THE EFFECT OF LINE VOLTAGE VARIATIONS ON THE MODEL DAB DIRECTION-FINDING EQUIPMENTS

MODIFICATION OF THE MODEL DAE DIRECTION-FINDING EQUIPMENTS

NAVY FIELD CHANGE NO. 1—ADD PRR SWITCH

FIGURE 1.—Schematic of circuit.

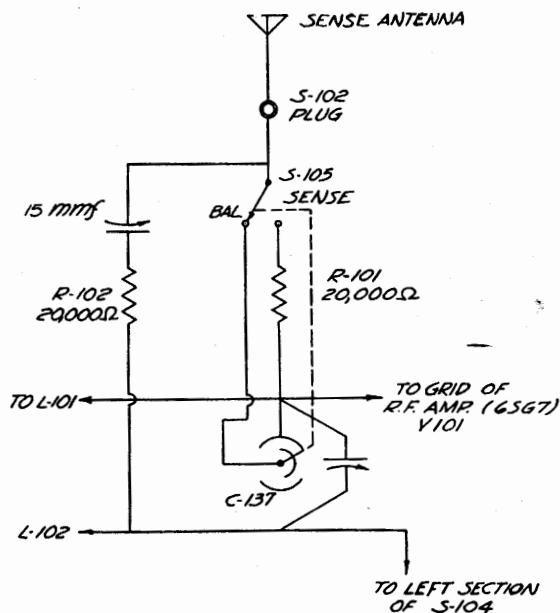
The faulty operation of the model DAE direction-finding equipment has been traced to the S-105 capacitor switch. It was noticed that stray in-phase voltage components were being introduced through the sense balance circuit and causing an unbalance to the loop circuit.

This fault has been corrected by installing a 15-micromicrofarad variable capacitor and a 20,000-ohm $\frac{1}{2}$ -watt resistor between the antenna and the tuning capacitor forming a balanced bridge circuit (see Figure 1). The stray in-phase component produced by the capacitance between the antenna and the sense resistor R-101 through

switch S-105 is opposed by the potential introduced by the 15-mmfd. variable capacitor and the 20,000-ohm resistor, causing these potentials to cancel. This in turn balances the loop circuit. It should be noticed in Figure 1 that R-102 must be of the same value as R-101 in order for the circuit to balance.

FIGURE 2.—Mounting position.

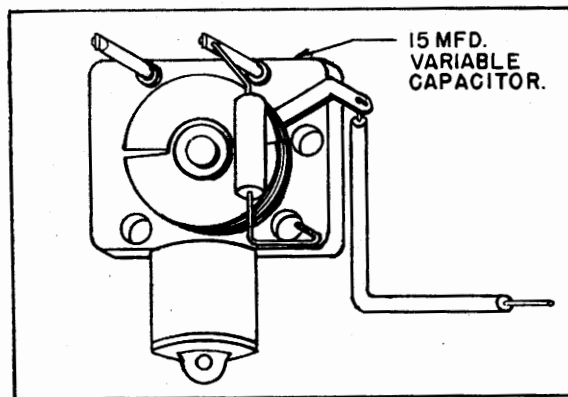
The 15-mmfd. variable capacitor and the 20,000-ohm $\frac{1}{2}$ -watt resistor should be mounted on an insulator pedestal as shown in Figure 2 and

FIGURE 3.—Mounting position.

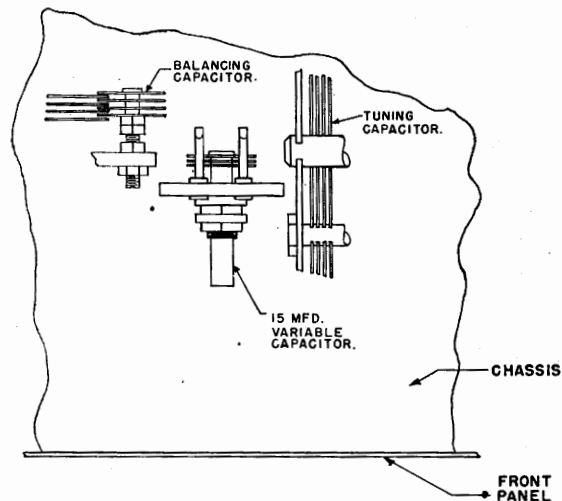
should be mounted approximately three inches back of the front panel of the case on the top side of the chassis midway between the balance capacitor and the tuning capacitor as shown in Figure 3. The rotor is connected to the antenna terminal of the sense balance switch and the free end of

the resistor is soldered to the forward side of the forward section of the balance capacitor stator.

FIGURE 1.—Terminal and top arrangement of loading coil.

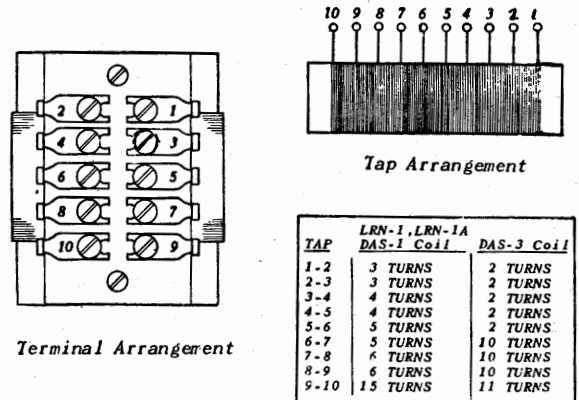
(1) Improper adjustment of the loading coil. In many instances the entire number of coil turns is used (from tap 1 to tap 10), and no attempt has been made to adjust the number of turns (by selecting appropriate taps) for maximum signal strength. The loading coil should be connected so that it is in series with the antenna lead-in and the center conductor of the coaxial cable. The active number of turns is the number between the two taps to which the two flexible leads (one from the antenna, one from the coaxial cable center conductor) connect. The tap arrangement is somewhat peculiar, as shown in Figure 1, and should be carefully noted.

Figure 1.—Schematic for field change no. 4 for LRN-1A.

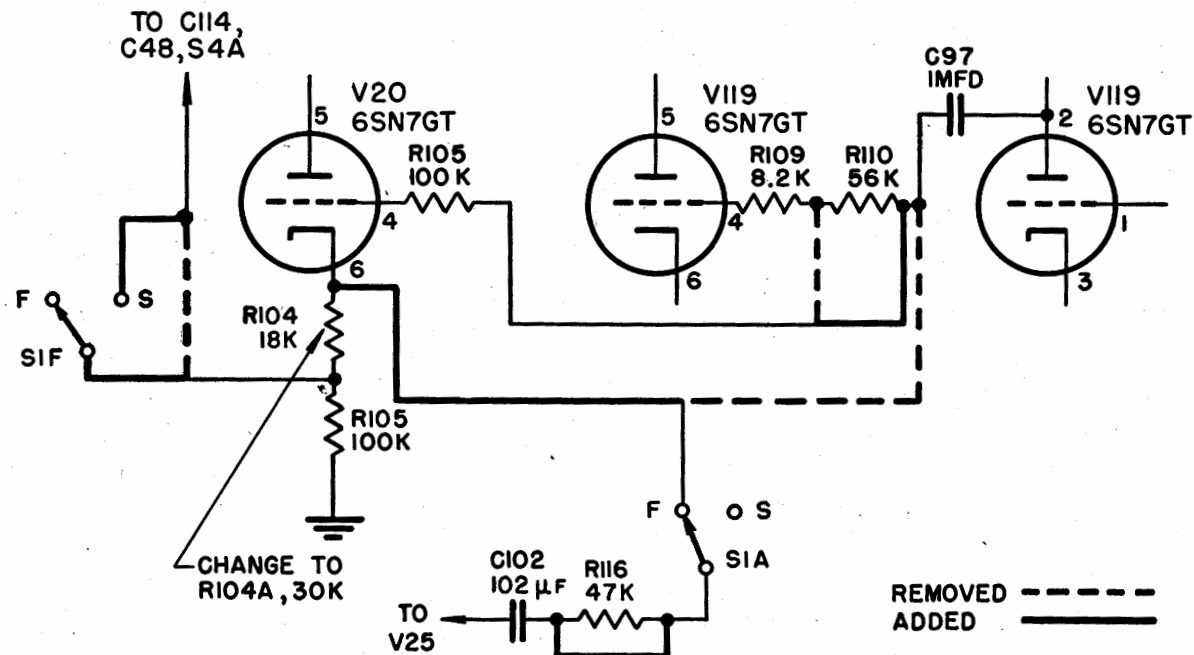
necessary in place of the original drive from the "on" tube of the pedestal generator delay multivibrator. The cathode follower, terminals 4, 5, and 6 of V-20, which normally serves to apply the pedestal-creating voltage to the vertical plates, is admirably suited to this purpose and is not necessary during the fast sweeps. Therefore, this design modification simply involves borrowing this cathode follower for an intensifier driver during the fast sweeps. Extra connections to existing switches are used, one existing resistor (R116) is shorted out, and one new resistor is needed (30K, 1/2-watt) to replace R104.

Referring to the accompanying diagram (Figure 1), the five steps necessary to accomplish this modification are as follows:

- (1) Disconnect the wire at the junction of R110 and C97 that runs from the pedestal generator V-19 to switch S1A, and connect it to pin 6 of V-20, the cathode follower.
- (2) Disconnect the wire at the junction of R109 and R110 which runs through R105 to pin 4 of V-20, and connect it to the junction of R110 and C97.

- (3) Short circuit R116.
- (4) Replace R104 with a 30K 1/2-watt resistor, R104A.
- (5) From the junction of R103 and R104A connect to an unused section of S1 (the slow-fast sweep switch) in such a way that the circuit will be closed back to C114 in the slow sweep position and open during the fast sweeps.

FIGURE 1.—Installation of a mounting board.

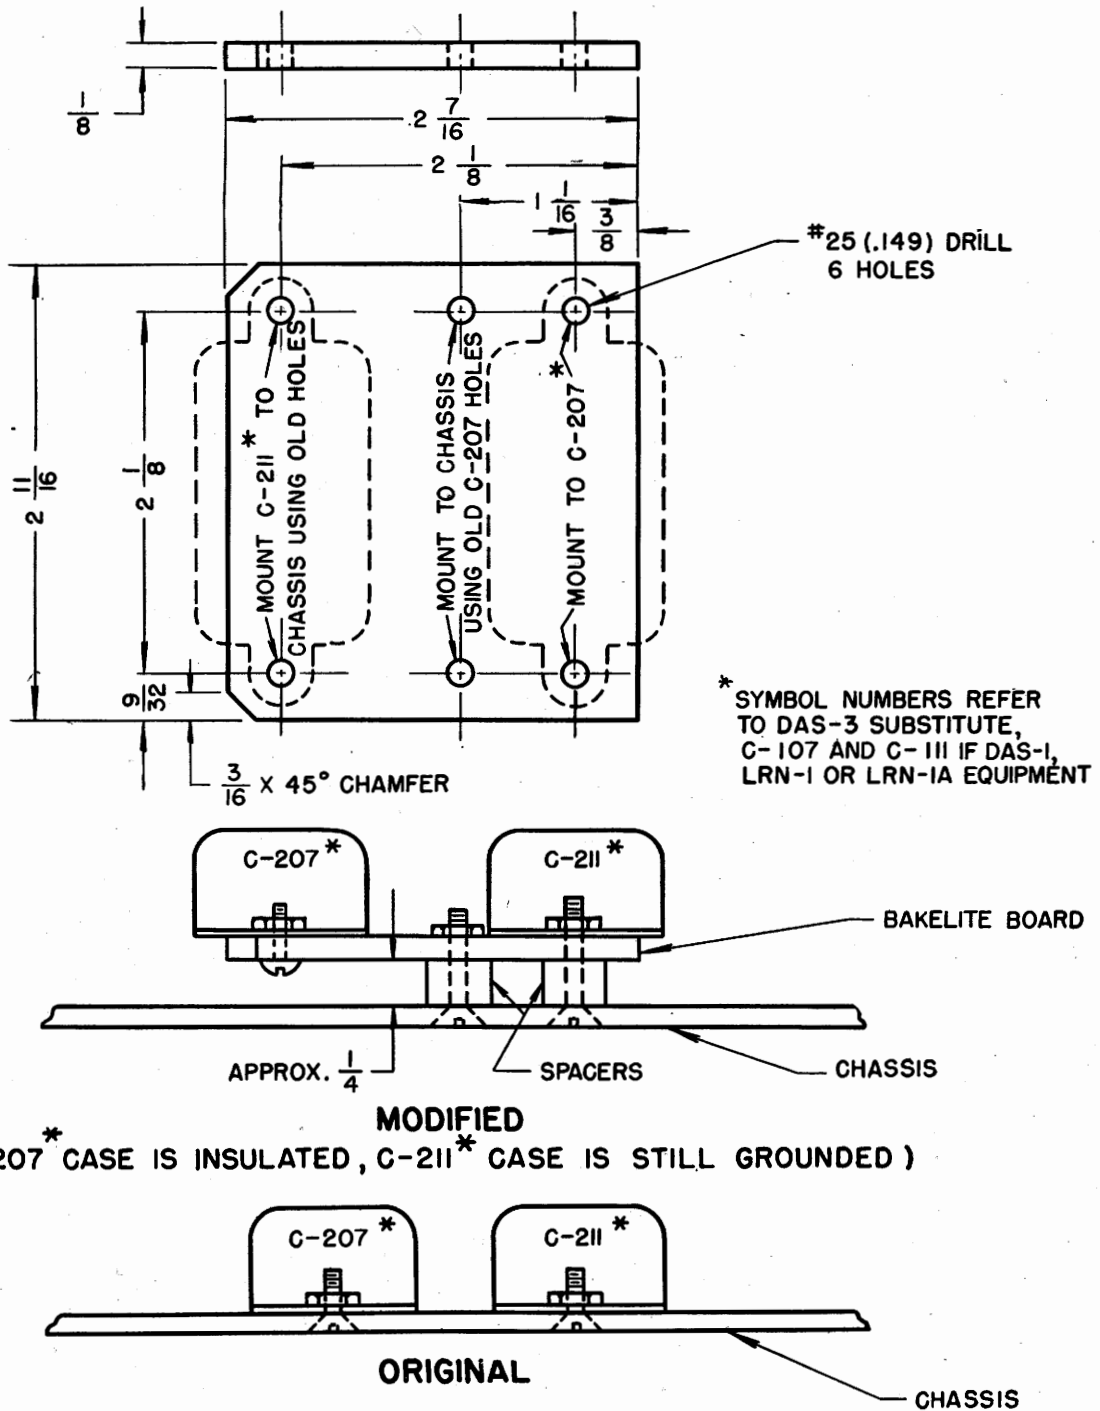
Indistinctness of the upper left dot in the #2 test jack pattern may occur if C107 in DAS-1 or C207 in DAS-3 has a high capacity to ground. Different makes of capacitors vary greatly in this respect. The difficulty can be completely eliminated by insulating the case of C107 or C207 from ground by means of a mounting board of bakelite or other non-conducting material. As a convenience both C107 or C207 and C111 or C211 should be mounted on the board as shown in diagram of Figure 1 but only C107 or
